RE: Ridge Runner #13-17
Township 14 South, Range 7 East
Section 17
Emery County, Utah

Ridge Runner #11-20
Township 14 South, Range 7 East
Section 20
Emery County, Utah

APPLICATION FOR PERMIT TO DRILL, DEEPEN, OR PLUG BACK

9. WELL NO.
#11-20

LOCATION LAYOUT FOR

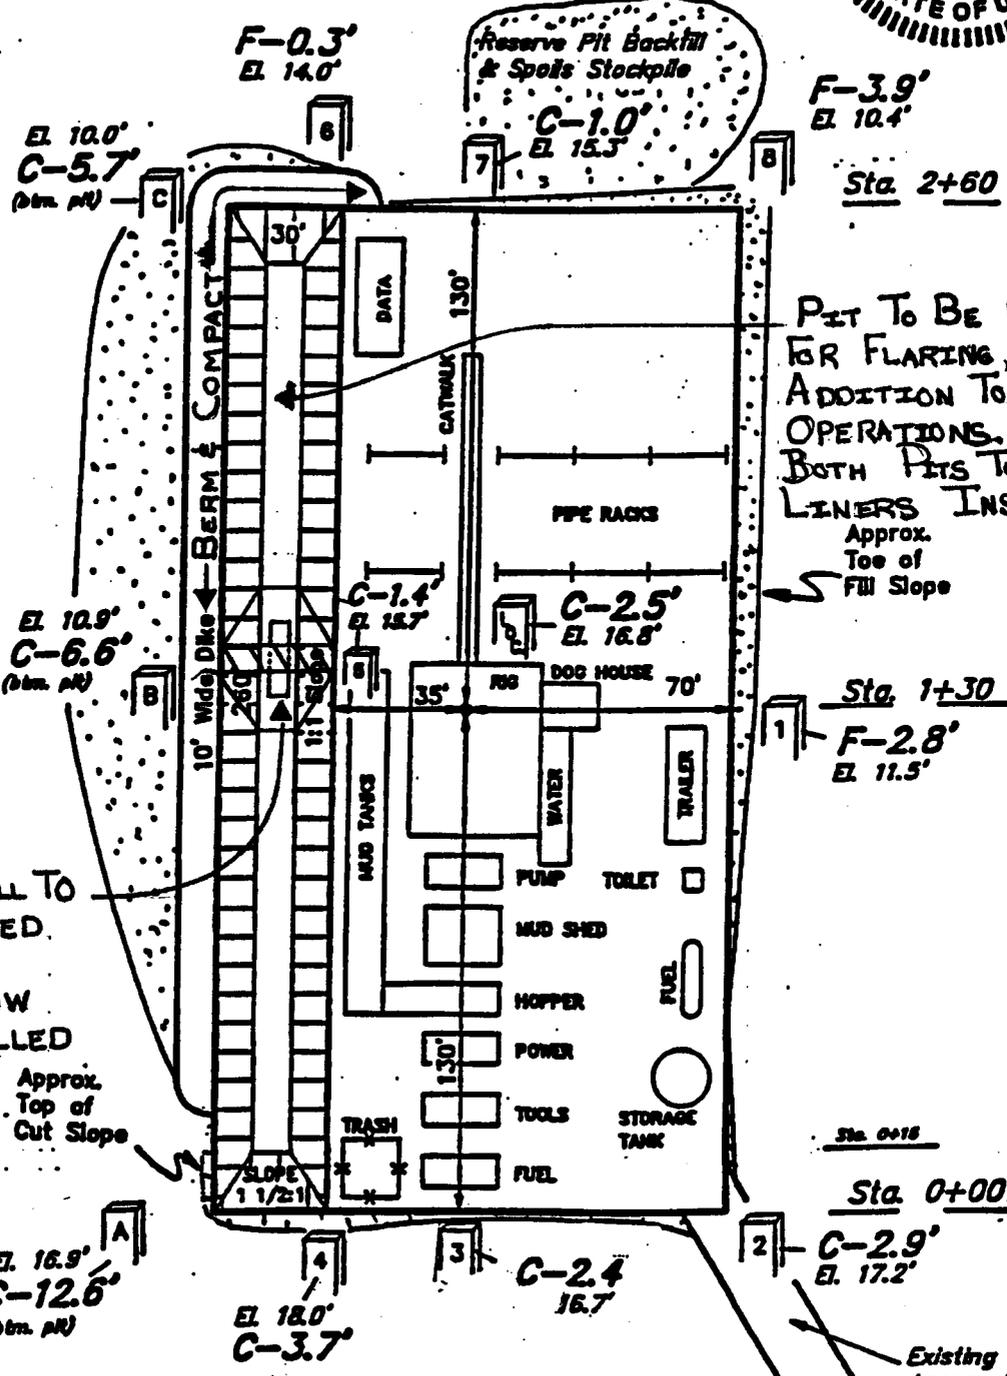
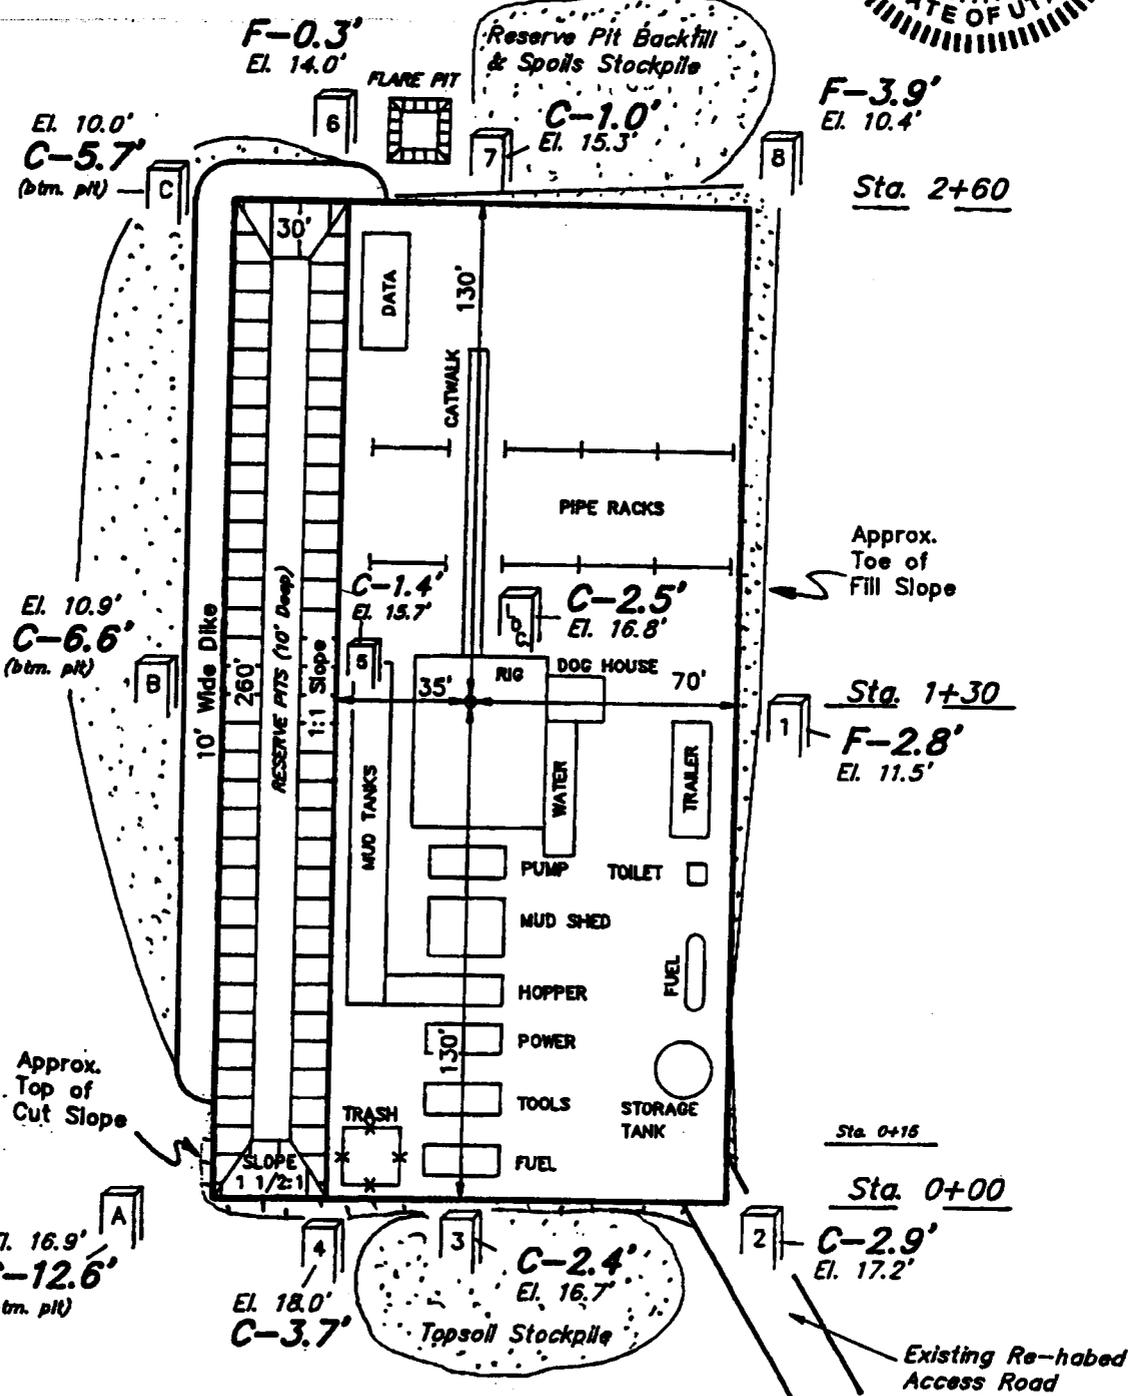
The location layout plan for the Ridge Runner #11-20 indicated a single pit, 260' in length by 30' in width to be constructed. Changes to this design involve installing a retaining wall, approximately midway in the pit, with a overflow pipe connecting both pits.

The southern pit half will also be utilized as the flare pit. Previous plans indicated a remote flare pit between survey markers #6 and #7.

Original plan and revised plan attached.

RETAINING WALL TO BE CONSTRUCTED BETWEEN PITS WITH OVERFLOW PIPE INSTALLED

PIT TO BE UTILIZED FOR FLARING, IN ADDITION TO DRILLING OPERATIONS. NOTE - BOTH PITS TO HAVE LINERS INSTALLED
Approx. Top of Full Slope
